SUBJECT: Application for amends to licenses NPF-41,NPF-51 & NPF-74.  
Amends would provide temp method to respond to sustained  
degraded switchyard voltage. O

**Subject: Palo Verde Nuclear Generating Station (PVNGS)  
Units 1, 2, and 3  
Docket Nos. STN 50-528/529/530  
Proposed Amendment to Technical Specification  
3/4.8.1.1, A.C. Sources - Operating**

**PROPOSED AMENDMENT TO TECHNICAL  
SPECIFICATION SECTION 3/4.8.1.1  
A.C. SOURCES - OPERATING**

Figure 1

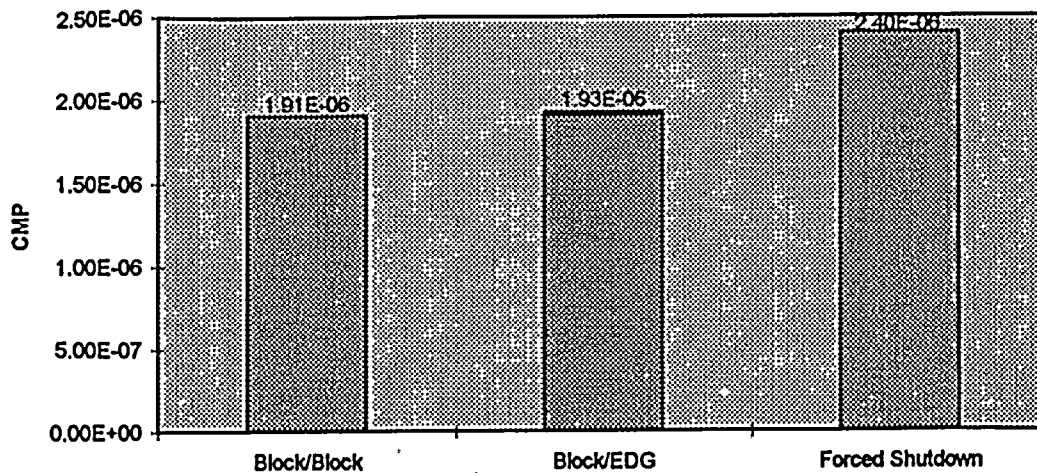
The PRA has shown that the probability of a core melt event during power operation with FBT blocked in one train after one hour for the next seventy one hours, and in the second train after two hours for the next seventy hours, is approximately  $1.91\text{E-}6$ . The probability of a core melt event during power operation with FBT blocked in one train after one hour for the next seventy one hours and the EDG powering the opposite train after the second hour for the next seventy hours (the proposed configuration) is between approximately  $1.91\text{E-}6$  and  $1.93\text{E-}6$ . A range is provided because the current PRA model can only model blocking both trains or the EDGs supplying both trains. The risk lies somewhere between the two values. The probability of a core melt event due to a normal shutdown assuming the plant is in a normal configuration and no other transients or accidents, except an uncomplicated reactor trip, occur during the shutdown process is  $2.4\text{E-}6$ . The risk can not be calculated for a forced shutdown with degraded switchyard voltage present but it is expected to be higher. The results are summarized graphically in Figure 1.
